41-59 Battersea Park Road

Design and Access Statement Addendum 03

This Design and Access Statement Addendum has been prepared by Howells on behalf of Watkin Jones Group ('the Applicant') in support of an amendment to an existing planning application Ref: 2022/1835, submitted in April 2022, for the redevelopment of 41-49 (Bookers) and 49-59 (BMW) Battersea Park Road ('the Site') within the London Borough of Wandsworth ('LBW').

Proposed L01 + L02 Plan

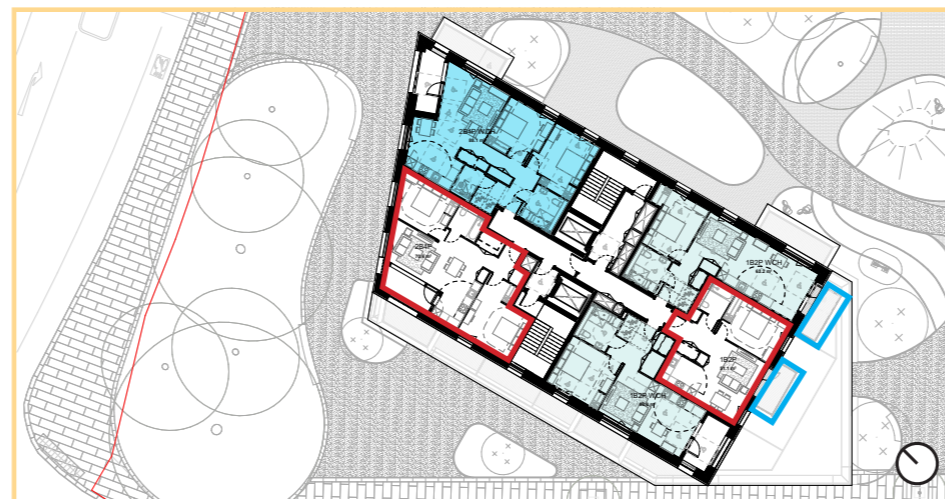
As shown in the adjacent plans the core arrangement has been reconfigured incorporating additional space for the 2B4P unit to the northwest of plot 1.

This alteration has helped address various comments on the layouts and increase the internal areas as illustrated on the adjacent stacker plans and described below.

Area changes to each wheelchair apartment are detailed below.

Level 01 - 2B4P W (Accessible)

- Submitted: 77.3 m²
- Proposed: 84.2 m²

Level 02 - 2B4P W (Accessible)

- Submitted: 77.3 m²
- Proposed: 84.2 m²

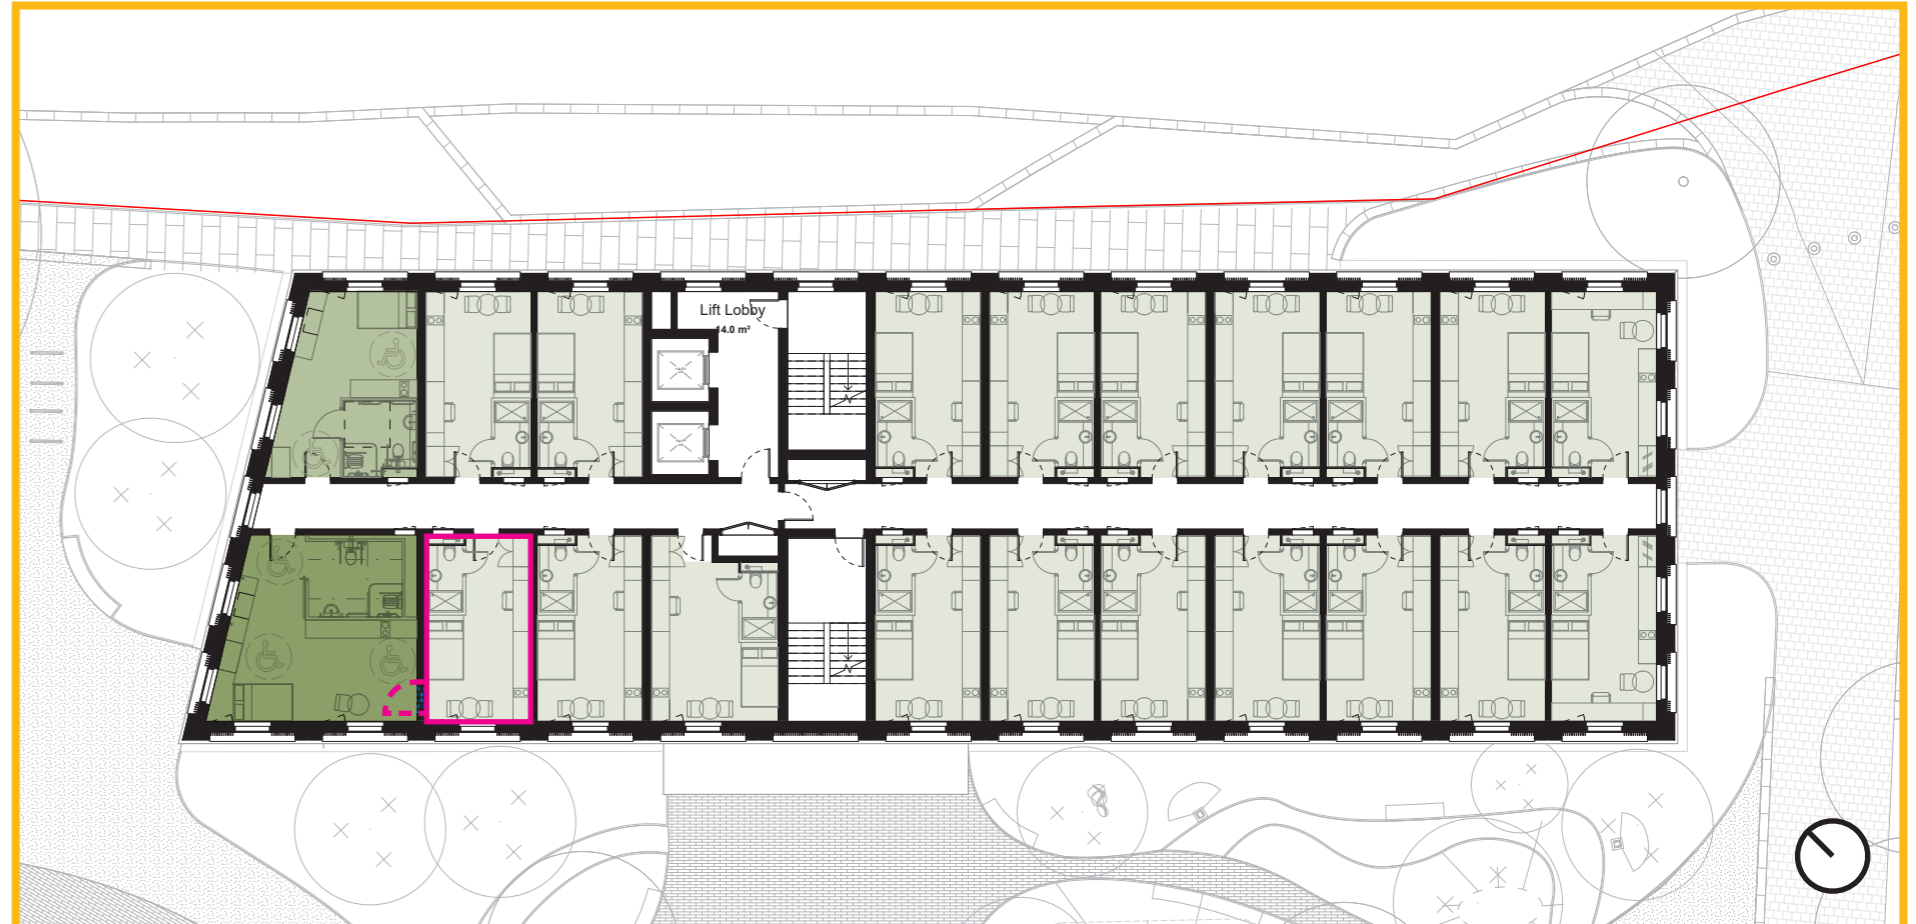
Within Plot 2 the number of wheelchair accessible and adaptable units has been altered to address comments. The changes have looked to rebalance distribution of adaptable and accessible units across plots 2 and 3 while integrating bathrooms suitable for hoist systems and soft spots for connecting doors to adjacent carer's rooms.

Of Plot 2's 237 studio bedrooms, 12no wheelchair accessible and 12no wheelchair adaptable studio bedrooms are incorporated, designed according to the London Plan and BS8300 2:2018 to have suitable bathrooms, kitchens, and manoeuvring spaces.

- 12no wheelchair accessible units - 1no per floor (L01-L06) + (L08-L13)
- 12no wheelchair adaptable units - 1no per floor (L01-L06) + (L08-L13)

The units equate to 5% accessible (including 1% hoisted units) and 5% adaptable & 10% within the block overall.

Of the 12no wheelchair accessible units 3no will be capable of integrating a hoist system with a connected carer's room adjacent. These units will be at L01 - L03 and included within the 12no accesible units. Details on these units are provided below. These 3 units provide in excess of the 1% required.

The proposal is to provide the bathroom and strengthening in the slab to provide a track or cast-in system to accept future track in the slab, above the ceiling.

For the adjoining carer's access door the drawings indicate the location of the door and provide framing within the partition system to allow future installation.

Pair of Cluster Units (not adapted)

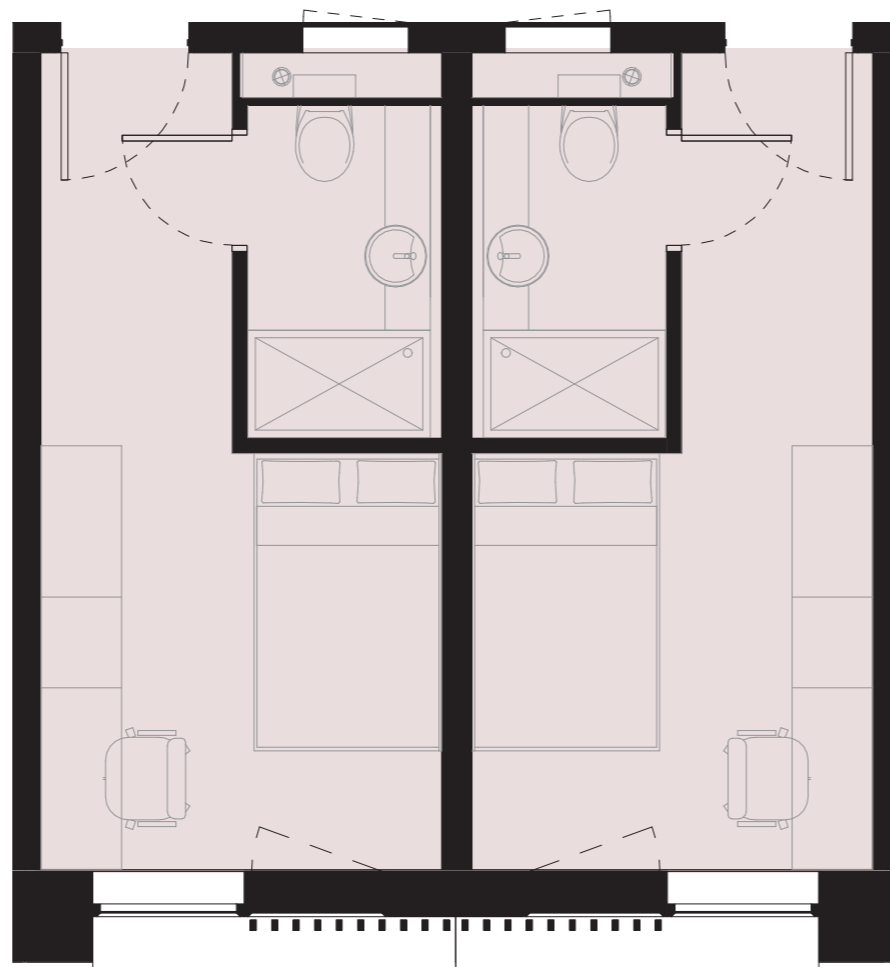
The proposed strategy for provision of adaptable rooms within plot 3 is that these units will be converted from a pair of cluster to a single accessible unit should these additional accessible units be required.

These rooms can be converted through the removal of the central wall and installation of an accessible shower in the location of the previous pod. Risers will remain in their original position and furniture will be replaced as illustrated in the adjacent diagrams.

This strategy means that Plot 3 has the capacity to meet the required 5% adaptable rooms and overall provision of 10% adaptable and accessible rooms.
